SIGN – A - RAMA COMMERCIAL SUBDIVISION

APPLICATION NUMBER 14 DATE October 2, 2003
APPLICANT Sign-A-Rama Commercial Subdivision
REQUEST Subdivision

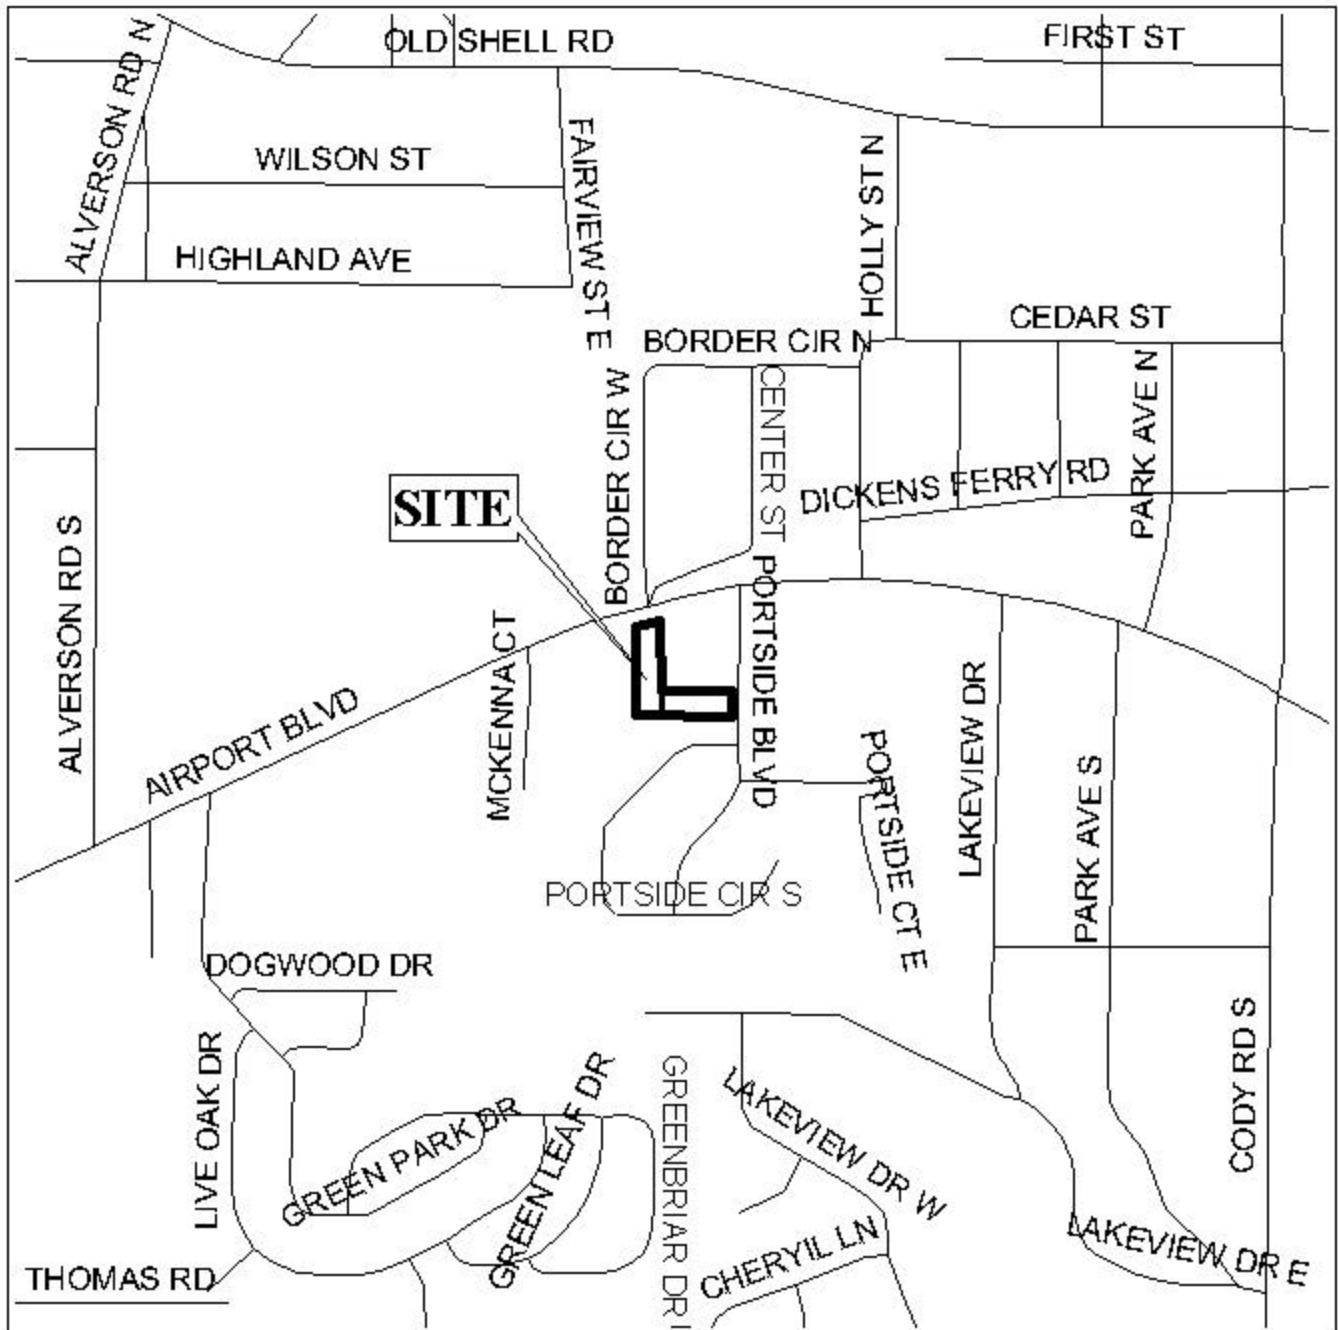
As proposed, Lot 1 would exceed the width to depth ratio, therefore a waiver of Section V.D.3. would be required.

The twenty-five foot minimum setback line is not shown on Lot 1 but would be required on the final plat.

It should be noted that the vicinity map depicts buildings crossing property lines; however, the site plan submitted does not illustrate any encroachments.

With modifications and a waiver of Section V.D.3. (width to depth ratio), the plat meets the minimum requirements of the Subdivision Regulations and is recommended for Tentative Approval subject to the following conditions: 1) the placement of a note on the final plat stating that Lot 1 is limited to one curb cut to Airport Boulevard with the size, location and design to be approved by County Engineering; 2) the placement of a note on the final plat stating that Lot 2 is limited to one curb cut to Portside Boulevard with the size, location and design to be approved by County Engineering; 3) the placement of a note on the final plat stating that any lots which are developed commercially and adjoin residentially developed property must provide a buffer, in compliance with Section V.A.7. of the Subdivision Regulations; and 4) the placement of the 25-foot minimum setback line on the final plat.
